**CITY OF LA VISTA  
PLANNING DIVISION**

**RECOMMENDATION REPORT**

Multi-family housing / Apartments named Cimarron Terrace

RE: Rezoning & Conditional Use Permit Reviews 2009  
Cimarron Terrace Apartments, Lots 1 & 2, Cimarron Woods Replat Two  
Third Review of Final PUD, CUP and Final Plat  
TD<sup>2</sup> File No. 171-366.24

# E1 – Typical Boulevard Section

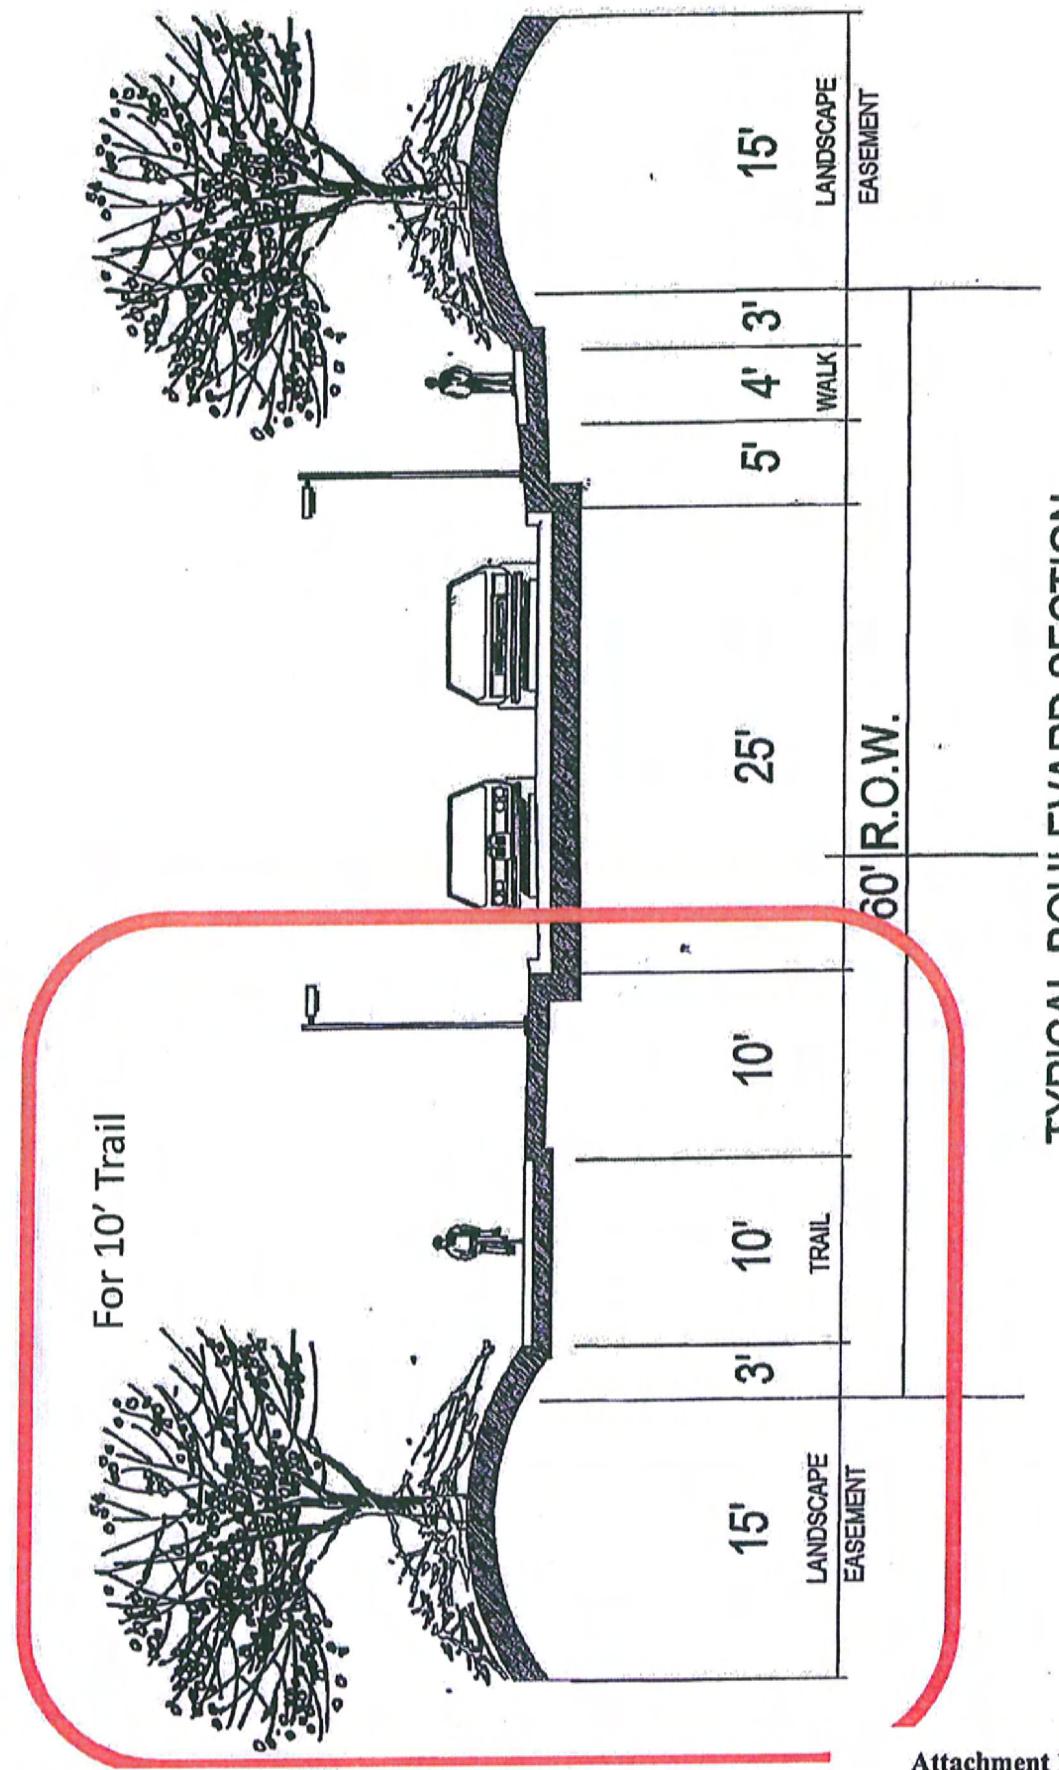
1. **Buffers Along Fence Line.** The proposed fence and sidewalk in the southwest corner of the property, abutting the townhouses on the western edge of Cimarron Woods, does not appear to comply with Planning Commissions recommendations. In April of last year, the Planning Commission recommended a 10-foot wide trail as provided in exhibit E-1 of the Cimarron Woods Subdivision Agreement. Attachment 1 is Exhibit E-1 of the Subdivision Agreement. As you can see, the Agreement requires a significant buffer between any fencing and the sidewalk and Pedcor's current plan does not provide for a buffer of any kind. Instead, Pedcor appears to propose to put the fence along the western property line of the western Cimarron Woods' properties immediately adjacent to the proposed trail. Attachment 2.

With respect to Item 1 regarding "buffers along the fence line", it is the Applicant's belief that the City does not want a fence along the trail. The Applicant is prepared to follow the direction with the City regarding this matter. In addition, I would also point out that the reference to Exhibit E-1 of the Subdivision Agreement relates to the landscaping that would be expected to occur along a boulevard, not along the trail with no adjacent boulevard or right-of-way.

# E1 – Walking trail, Harrison setbacks

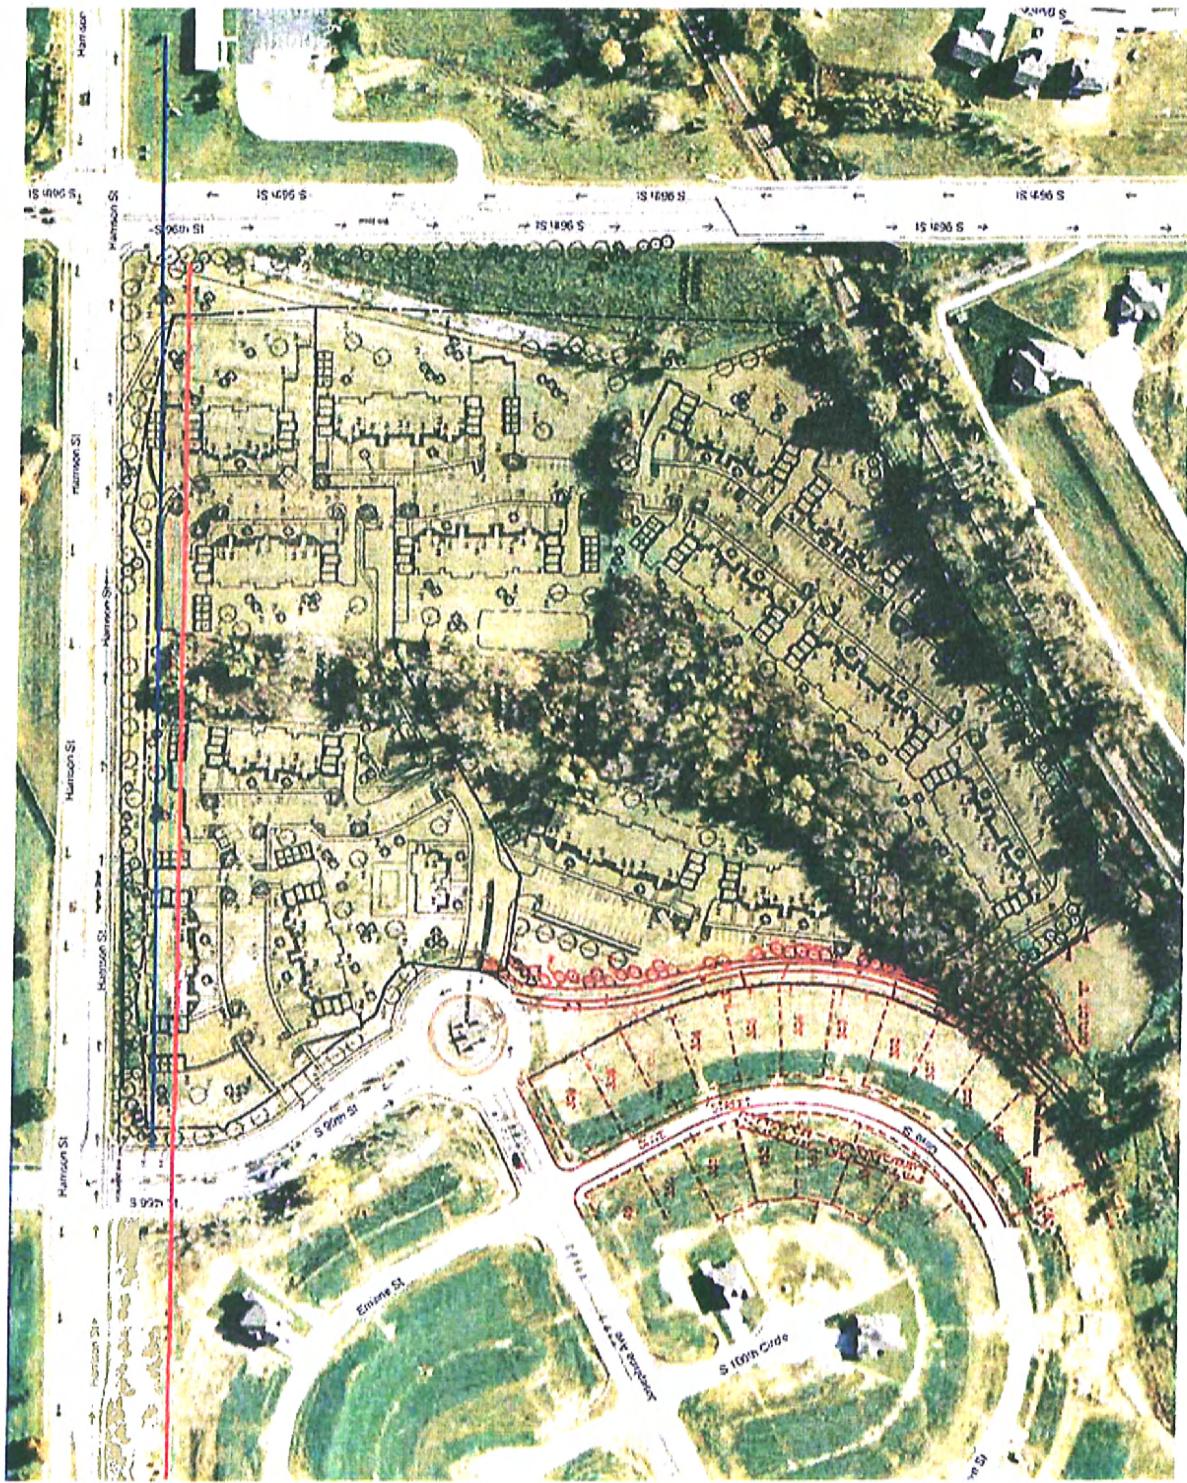
2. **Setbacks Along Harrison Street.** Several of the proposed apartment structures will be extremely close to Harrison Street. As set forth in the attached photograph, one can clearly see the setbacks required of all other surrounding structures and Pedcor's effort to place an apartment structure just off of Harrison Street. As shown in Attachment 3, the red line represents surrounding setbacks, while the blue line shows how close these structures will be to Harrison Street. Pedcor's proposal certainly does not comport with the surrounding structures

and, as part of the gateway corridor, we believe that the proposed setbacks should be increased to be consistent with the surroundings.

With respect to Item 2, the Applicant meets all site regulators relating to set backs. The site shows a 25 foot setback along Harrison Street. The 25 foot setback is more than sufficient to protect the health, safety and general welfare of the public. I would also point out that the drawing attached to the HOA letter is not to scale and is misleading.
